PUBLIC STORAGE

9701 AURORA AVE N., SEATTLE, WA

DPD PROJECT #: 3020310

DESIGN REVIEW BOARD MEETING: DESIGN REVIEW RECOMMENDATION #2

DRB REC #1 (6/5/17) DESIGN
NORTH FACADE (N. 98TH ST.)

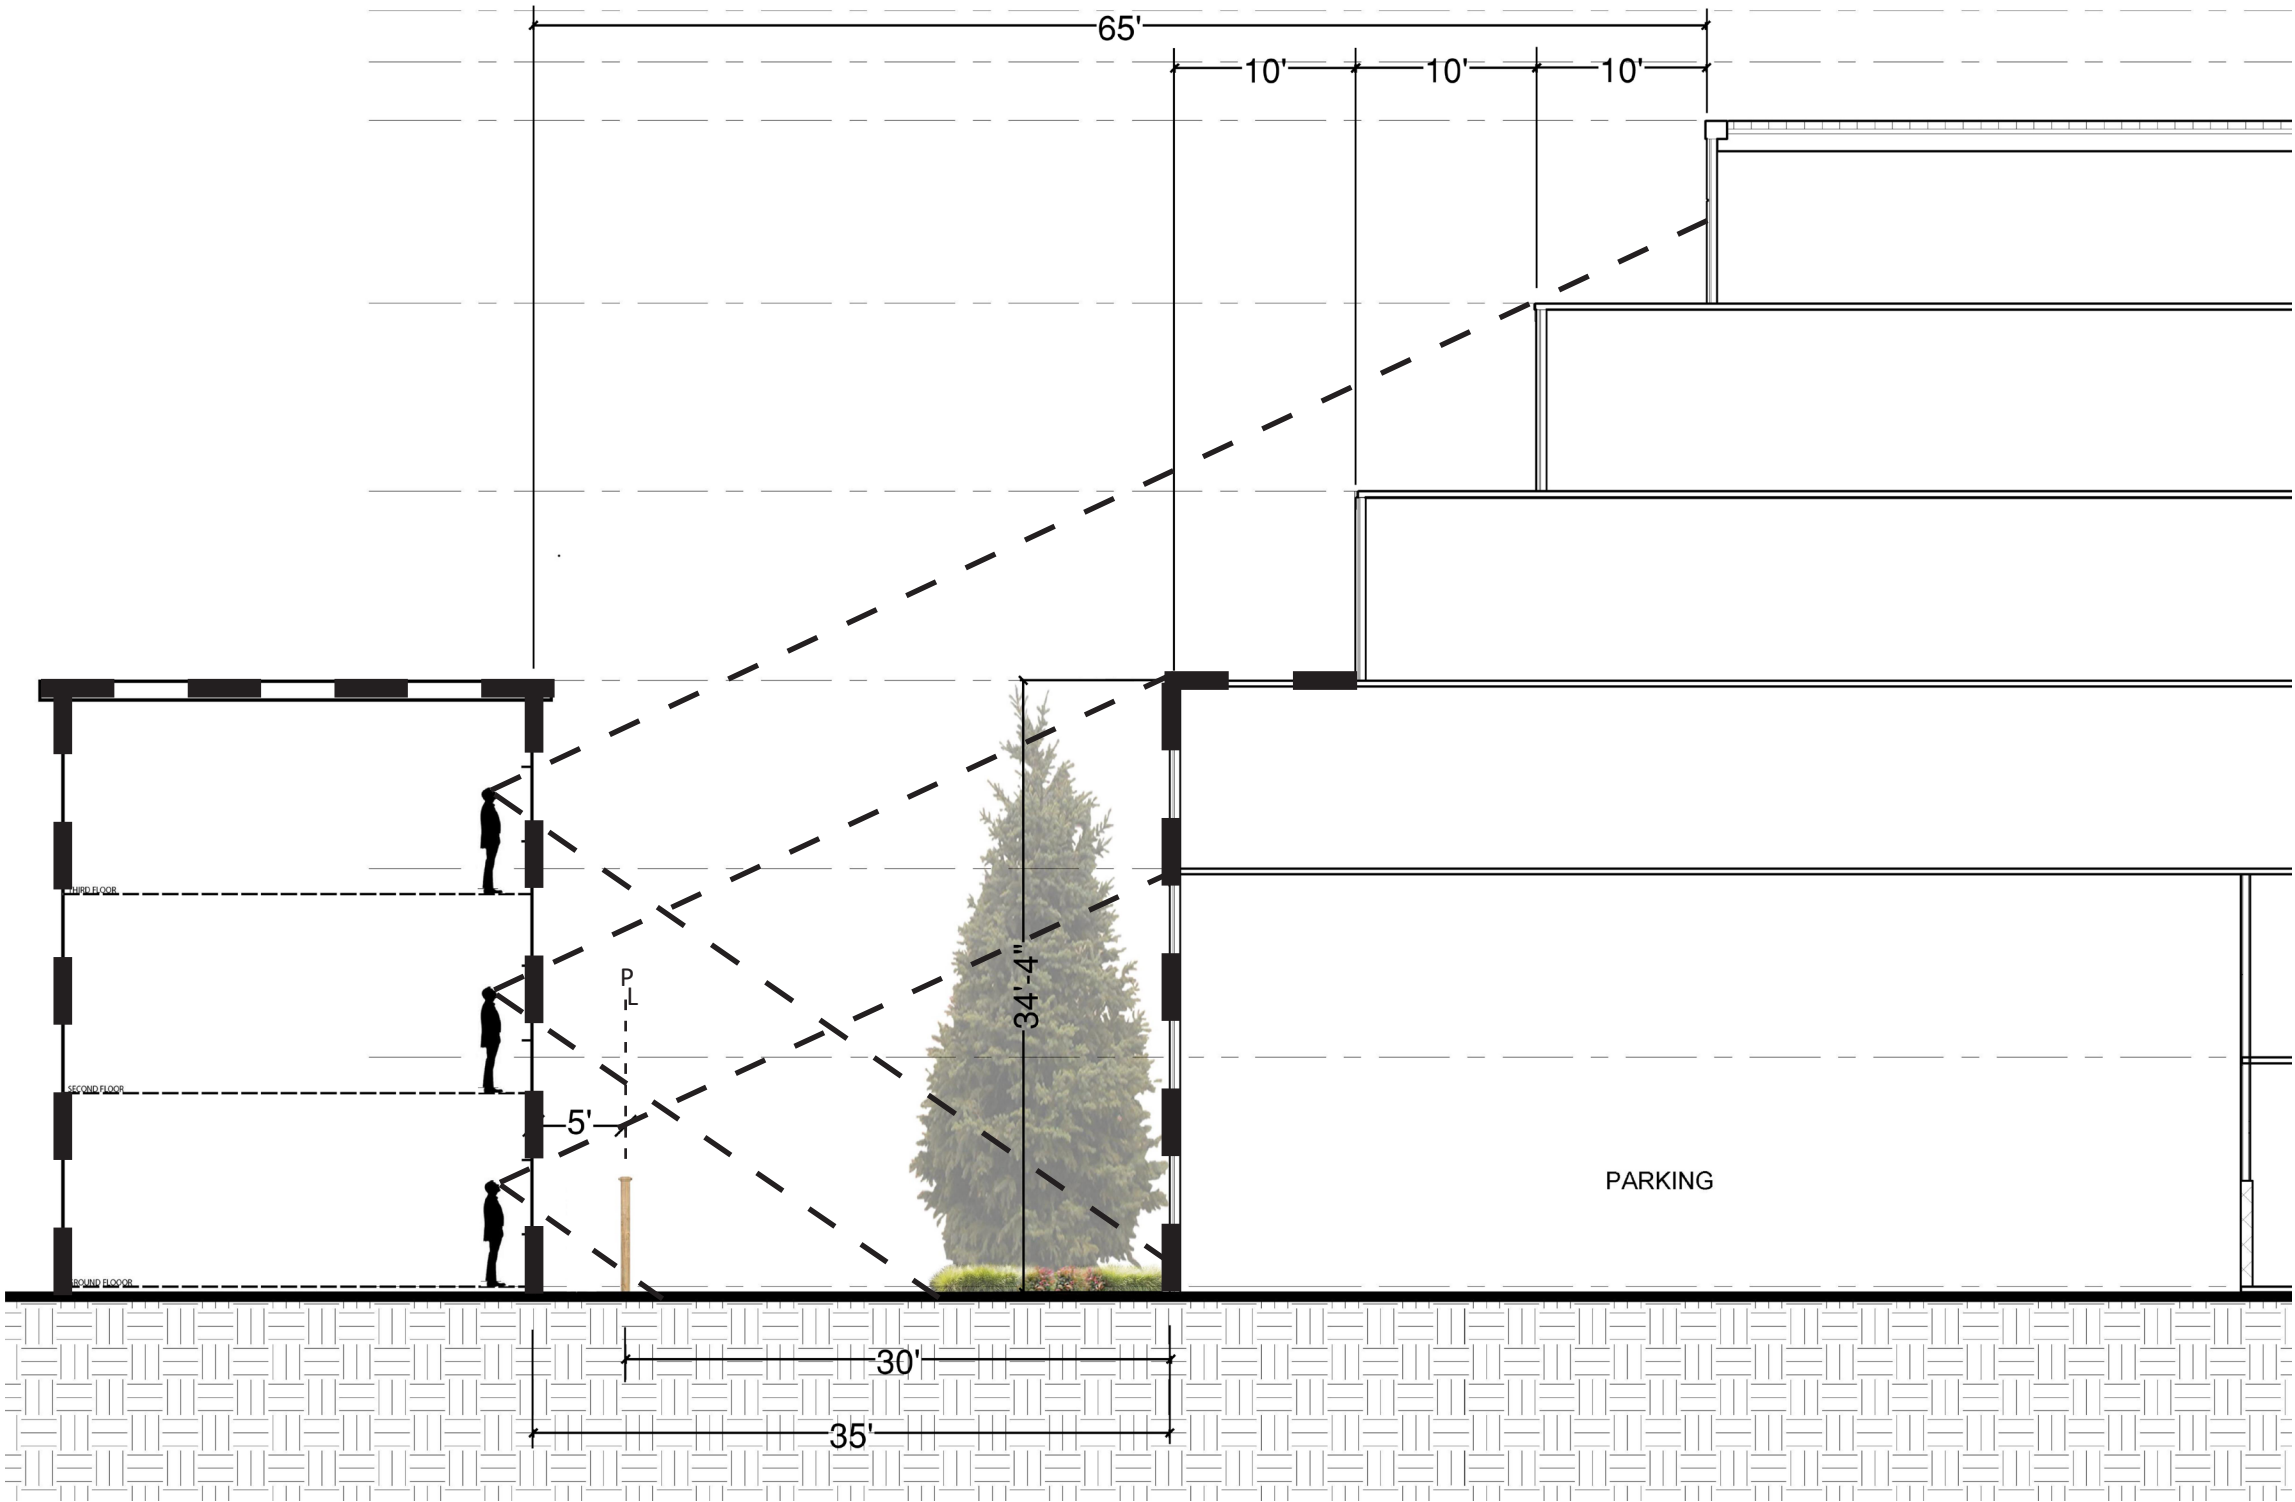
BOARD COMMENT:

The masonry on the building has been changed from concrete masonry units (CMU) to brick in colors that complement the overall project color palette. The height of the masonry base on the north and south facades has been increased to the top of the second floor.

The extent of the previously proposed orange wall area has been eliminated from the masonry at the tower elements and over the vehicle entrances and the tower legs. The extent of the orange has limited to the top ten (10) feet of the northeast and southeast corner towers.

All canopies proposed along the north, south and east facades have been changed from orange to black.

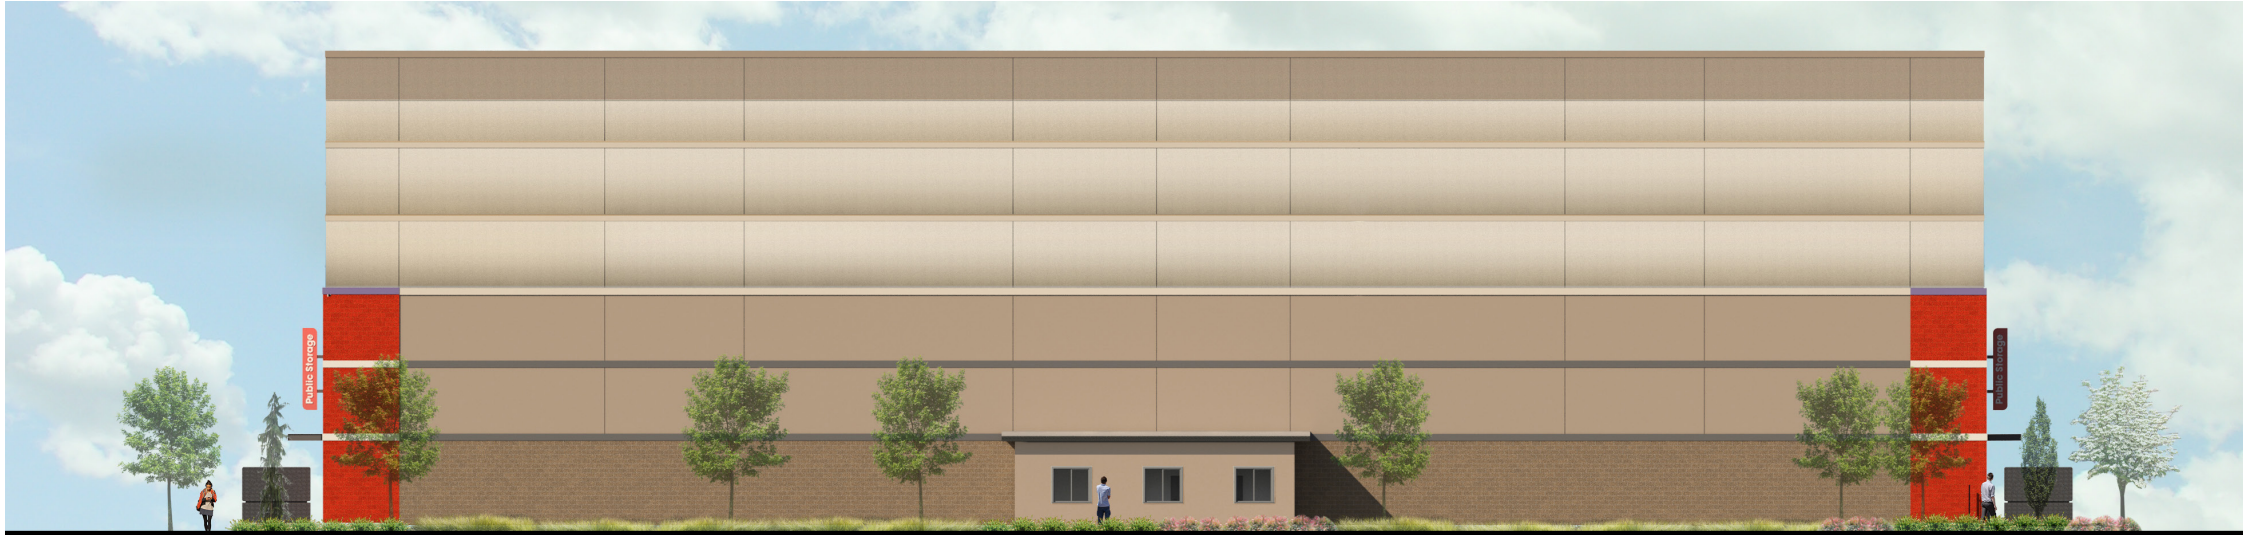
1.b. The Board agreed that the upper level setbacks at the west were a positive gesture to public concerns of impacts to the availability of light and perceived height, bulk, and scale, but were not convinced these setbacks adequately relieved perceived height from adjacent residential development to the west. Include in the second recommendation packet, sections illustrating the relationship of the proposal to the existing development to the west, include dimensions, provide graphics demonstrating lines of sight, and provide additional renderings viewing the building from N 97th and 98th Streets. These graphics should clearly demonstrate this scale relationship and how it is respecting the residential neighbors. (CS2-D)

The allowed setback per 23.47.014.B of the Seattle Land Use Code is zero for the first 13 feet of building height when abutting a residential zone along the rear or side lot line. A 10 foot setback is required for all portions of the building above 13 feet. The proposed Public Storage building is setback 30 feet from the rear (west) lot line for the first 23 feet of building height. The remainder of the building steps in 10 foot increments away from the rear (west) lot line.

The maximum allowable height for the subject site is 65 feet. To provide a positive transition from the commercial to the residential to the west, the Public Storage building will not take advantage of the maximum allowable height. Beginning at the fourth floor the building steps in ten foot increments along the western facade, resulting in a loss of allowable building height and square footage for the fourth through sixth floors.

The portion of the building closest to the western property line will be approximately 34'-4" in height, similar to that of the three story residential units to the west.

DRB REC #1 (6/5/17) - WEST FACADE)

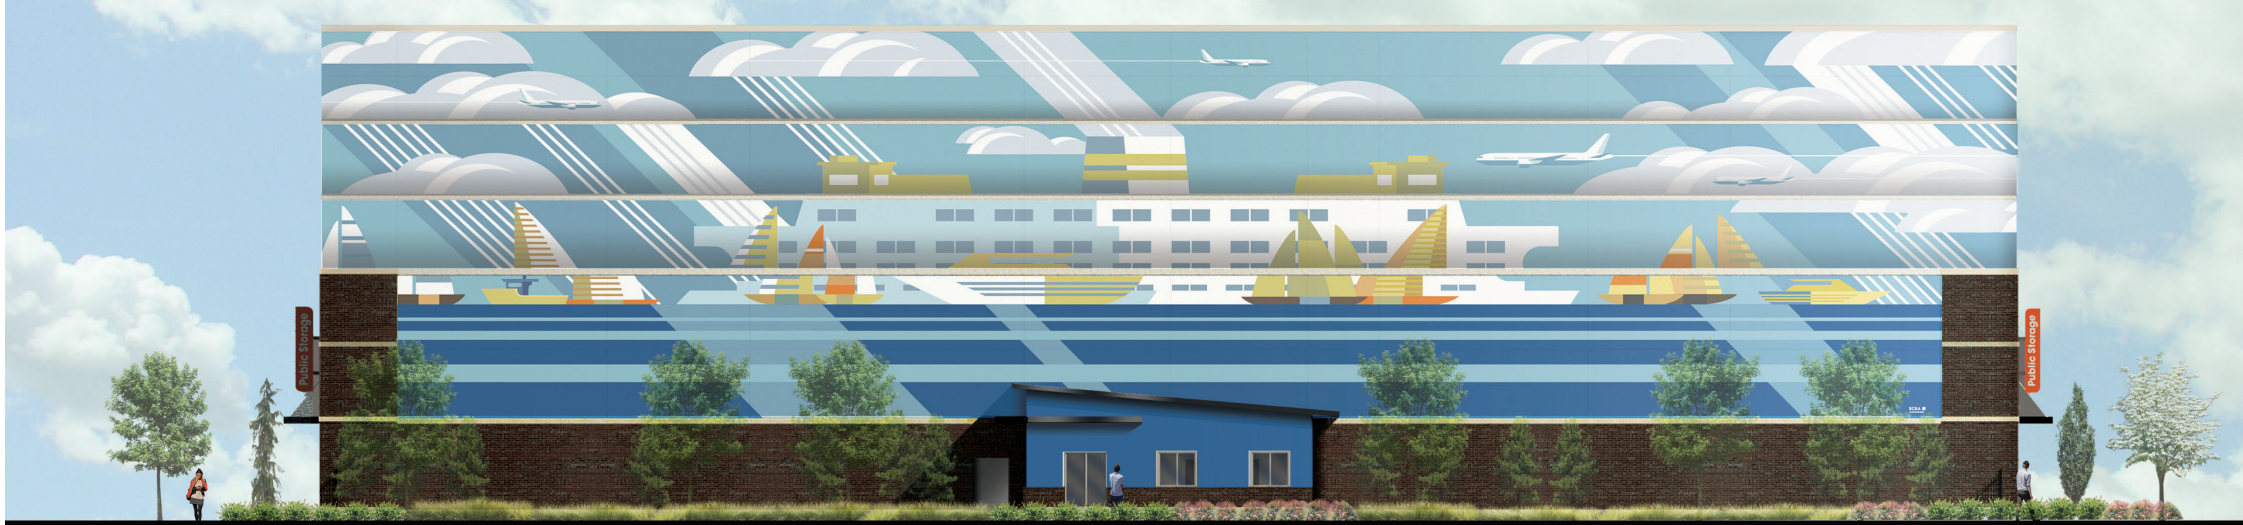
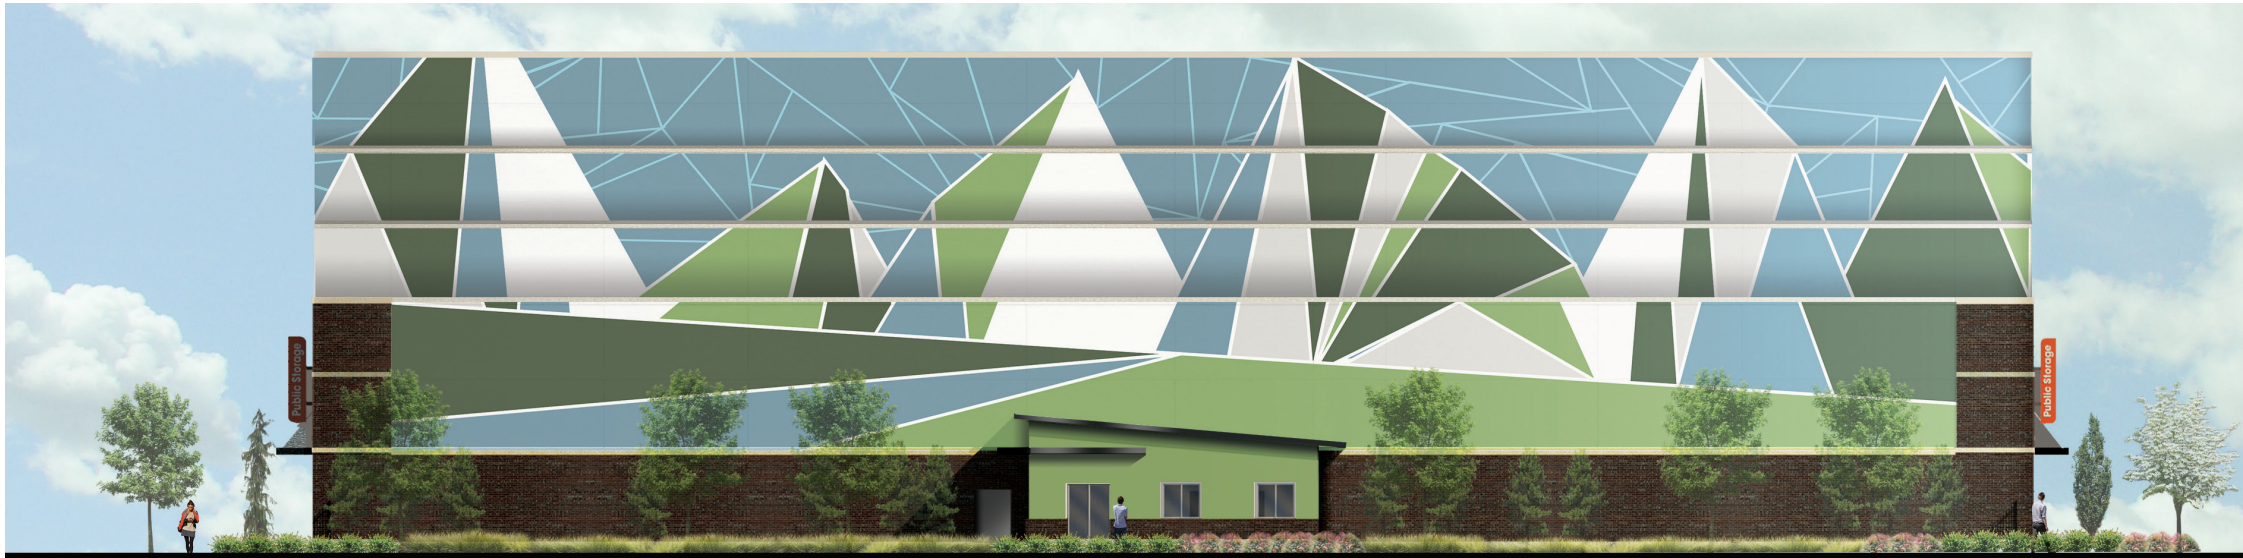
BOARD COMMENT:

The placement of the murals would provide the adjacent neighbors to the west with an interesting and artistic view. It also provides the neighborhood with community art, in abstract, that can be seen from both N. 97th and N. 98th. Both proposed options will cover the majority of the western facade, mitigating the concern of large expanses of blank walls.

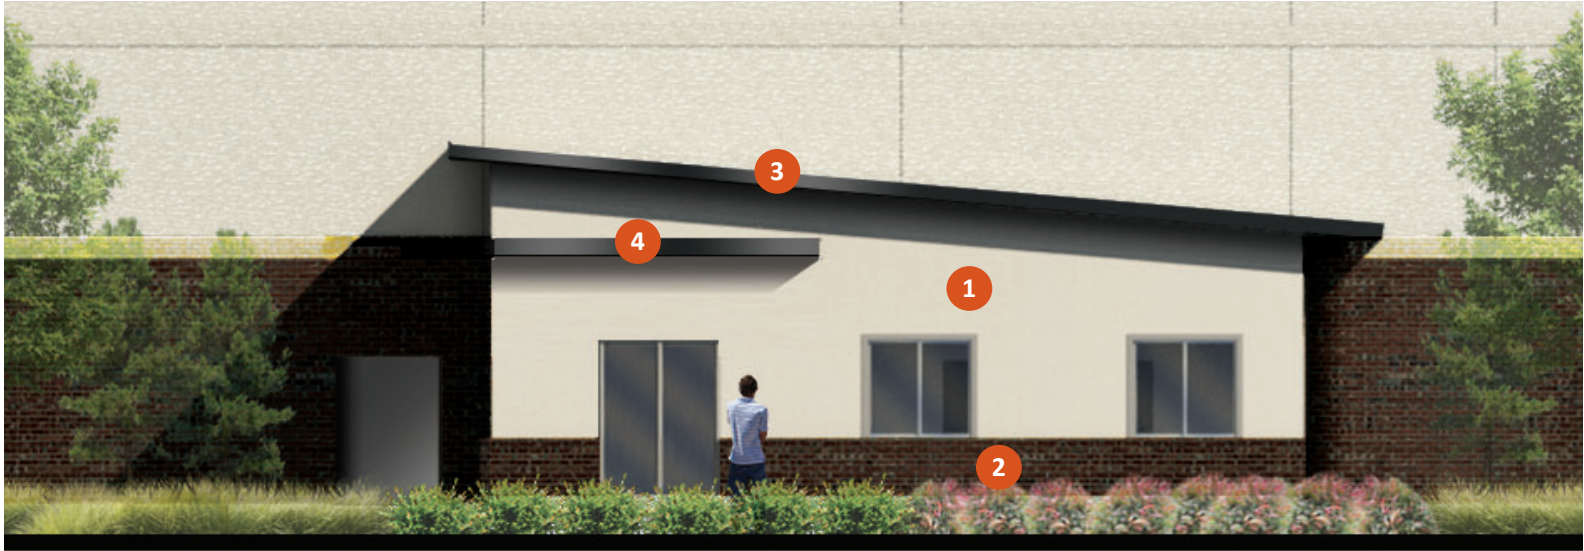
1.d. A caretaker’s apartment was proposed at the west portion of the site, attached to the structure at the center of the west elevation. It was not clear from the packet how this portion of the building is to be treated (Recommendation Packet dated June 5, 2017, page 37). While the Board agreed that due to its location this unit will not be readily visible from the street, it will be visible from adjacent single-family development to the west and deserves attention to detail. This unit should be residential in character and integrated into the architectural concept. Include in the second recommendation packet material and color details for this portion of the structure. (DC4-A)

- 1 Apartment siding material will be EIFS painted “Sand” to match the main building.
- 2 The lower siding material will be brick.
- 3 A single sloping roof will be used. A single sloping roof is similar to some of the residential buildings to the west.
- 4 A canopy will be added over the door on the north facade and will wrap around to the west for added character and interest.

DRB REC #1 (6/5/17) DESIGN
EAST FACADE (AURORA AVE N.)

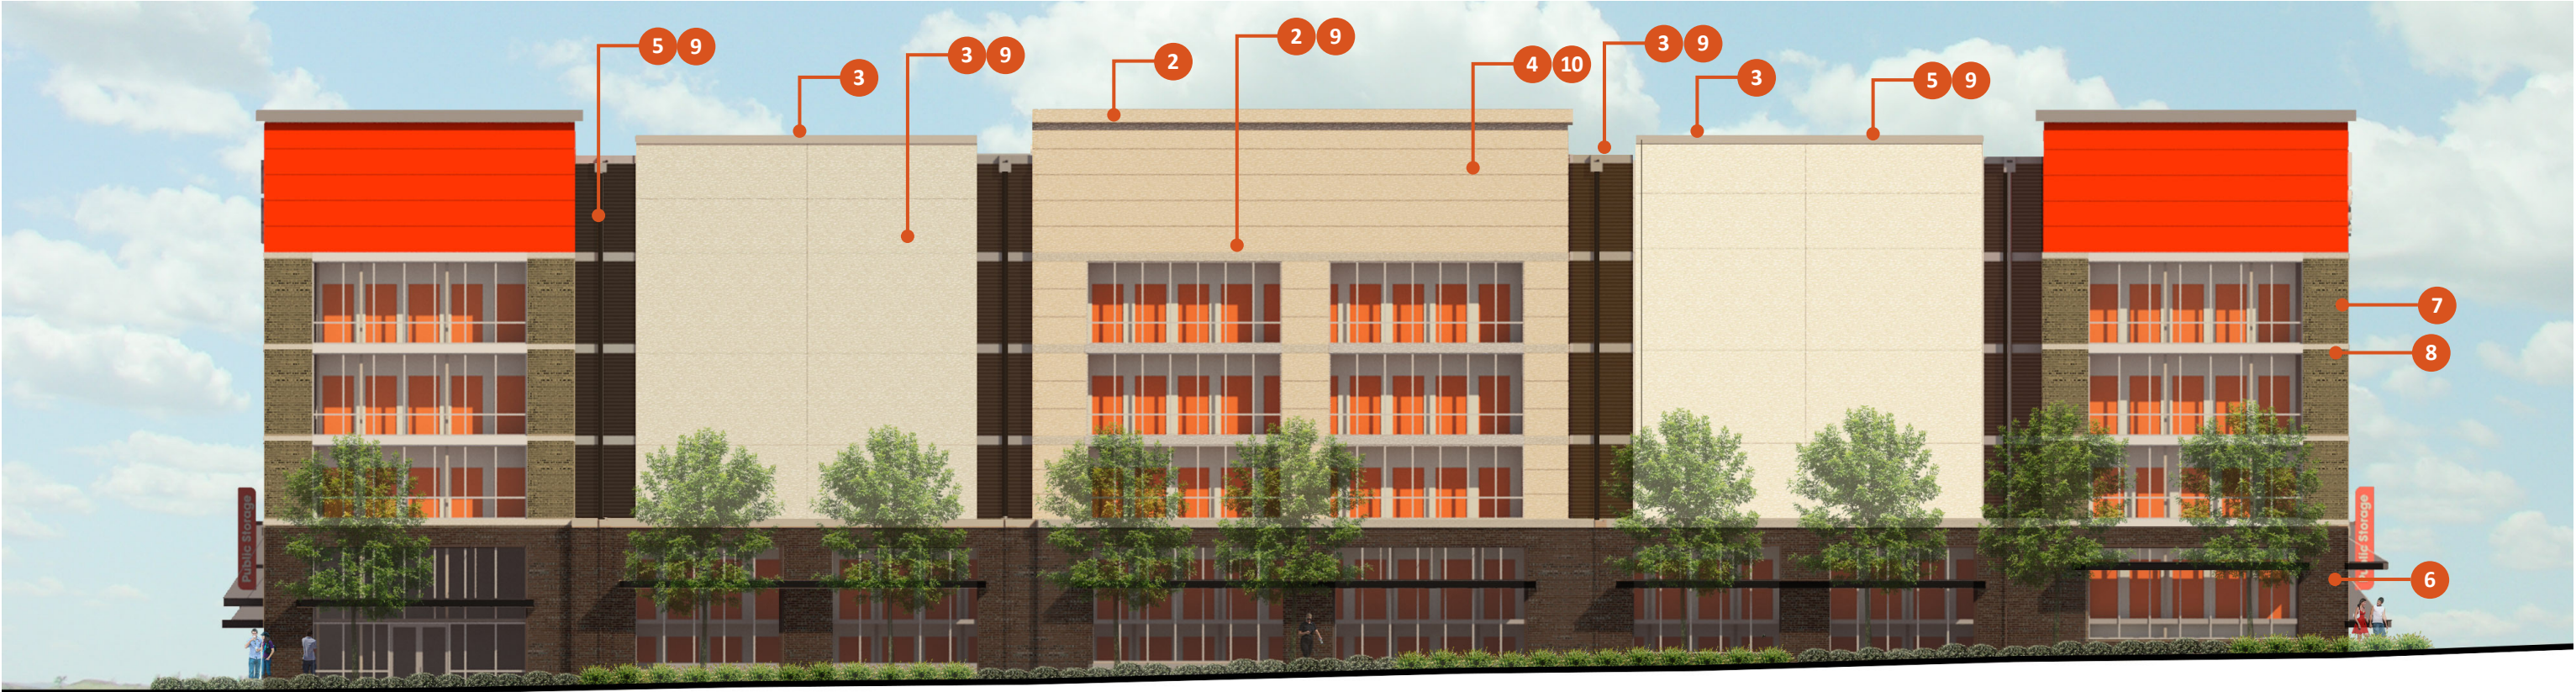
1.f. The Board found that the large blank wall conditions and weak base expression resulted in a composition that appeared out of proportion and unresolved. The Board recommended further development of the facades to mitigate (reduce or eliminate) blank wall conditions and strengthen the base expression. The use of brick was suggested by the public and the Board. (DC2-B)

The masonry on the building has been change from concrete masonry units (CMU) to brick in colors that complement the paint colors proposed. The brick at the base of the building on the north and south facades has been extended to the top of the second floor, similar to that of the east facade. This increase in the height of the masonry creates a stronger building base and reduces the perceived mass of the building.
